## ■ CRUISE CONTROL SYSTEM

### 1. General

#### ► System Diagram ◀

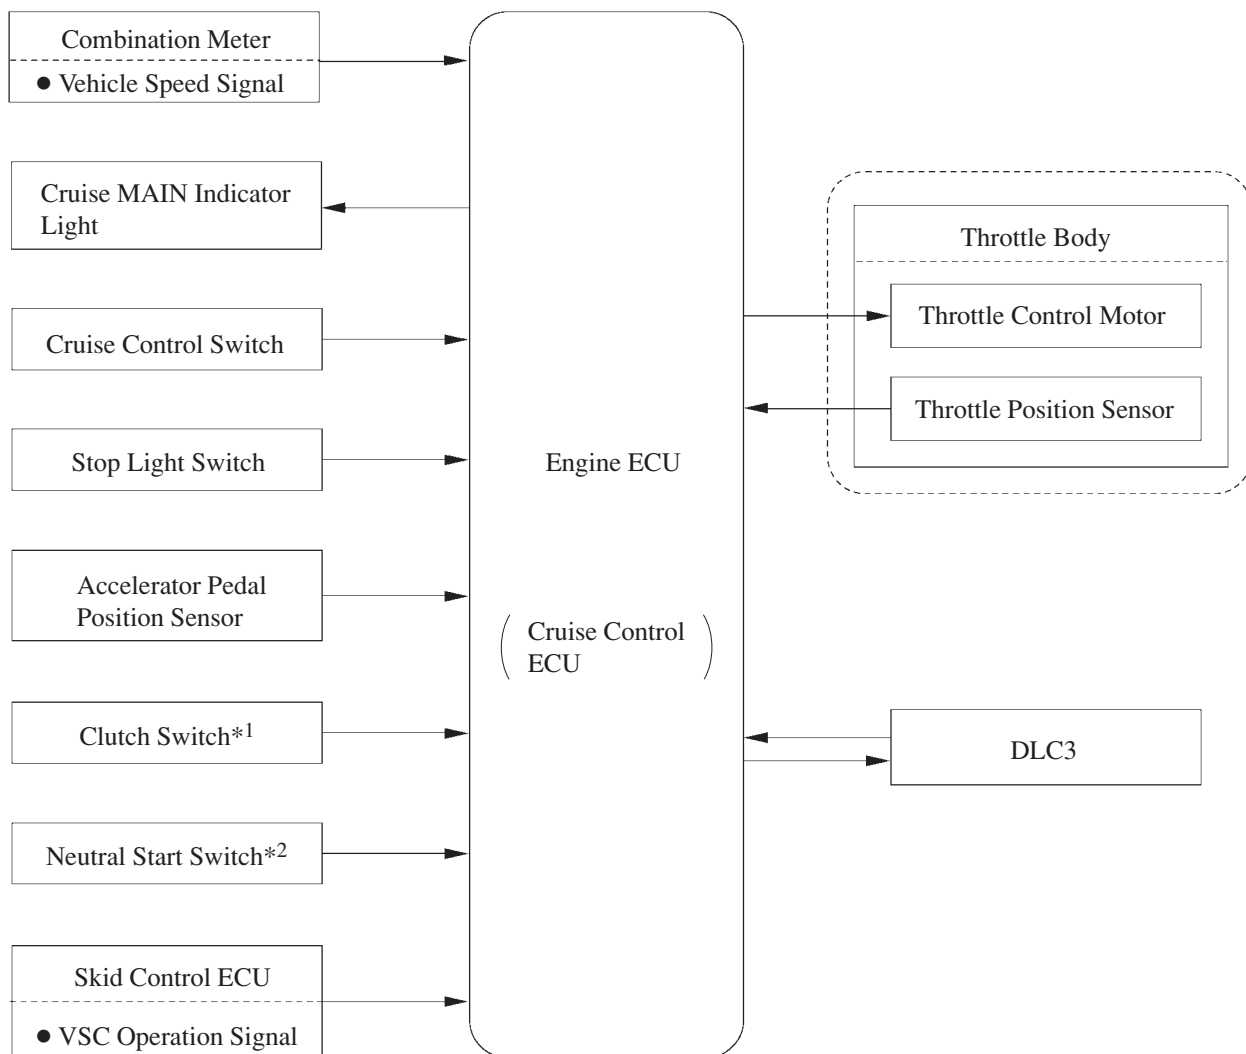
- Along with the adoption of the ETCS-i (Electronic Throttle Control System-intelligent) in the 1AZ-FE and 2AZ-FE engine, the cruise control system has been changed from the conventional actuator control to electronic throttle control.
- The cruise control ECU has been integrated in the engine ECU.
